PRODUCT INFORMATION to

BIL 20 / BIL 20 Au (9301761xx / 9301767xx)

BIL 30 / BIL 30 Au (9301661xx / 9301667xx)

BUG 10 / BUG 10 Au (9301751xx / 9301757xx)

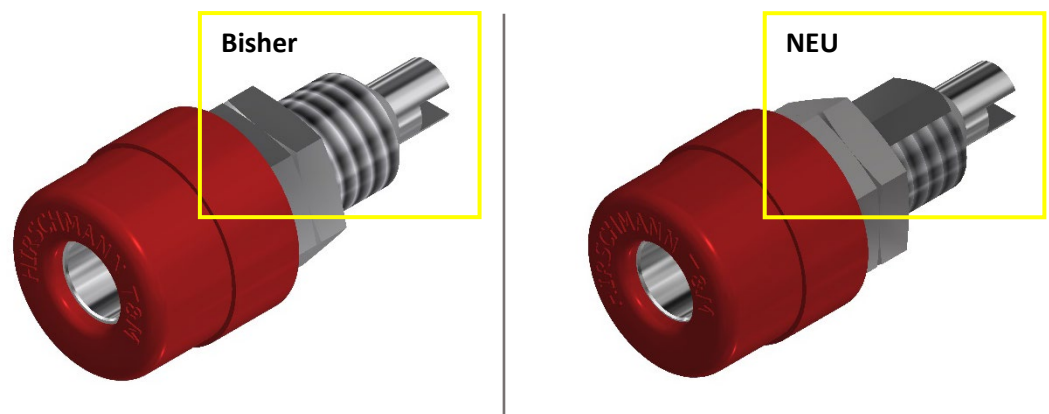
We would like to inform you about the following change to the products **BIL 20**, **BIL 30** and **BUG 10**. Due to the new requirement of the RoHS directive, we have changed the material of the contact socket to zinc die-cast.

The new production technology required a slight design change, which is visible through flattening. Previously, the socket had a circumferential thread (see picture). This adjustment has no effect on the function or technical properties.
